Product Change Notification

Change Notification #: 112367 - 00
Change Title: Intel® Server Chassis P4304XXSFCN
PCN 112367-00, Product Design, Label
Cable Changes and Label Updates
Date of Publication: June 17, 2013

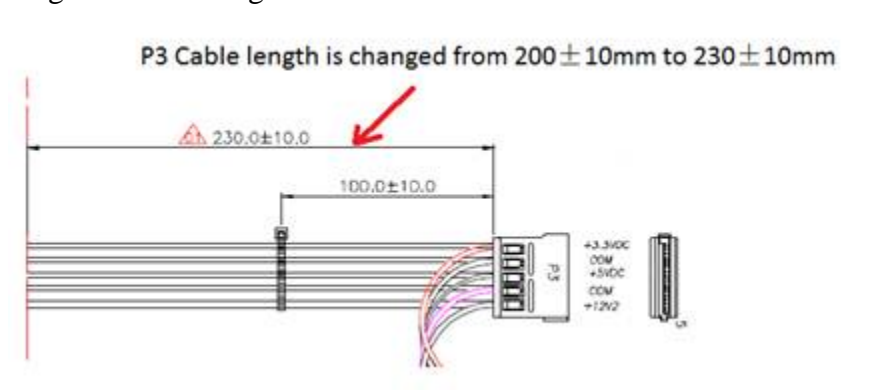
1. The cables on the power supply are being changed from E95763-005 to E95763-006 to improve connect ability. The following changes will apply:
 - a) Change the cable length of P1 from 170mm to 290mm

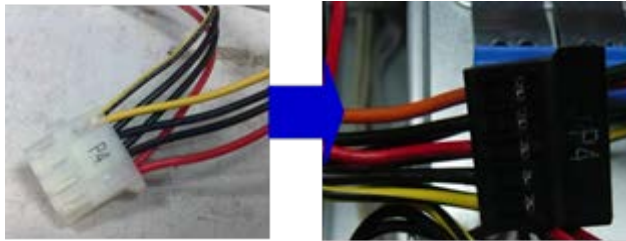
b) Change the cable length of P3 from 200mm to 230mm.
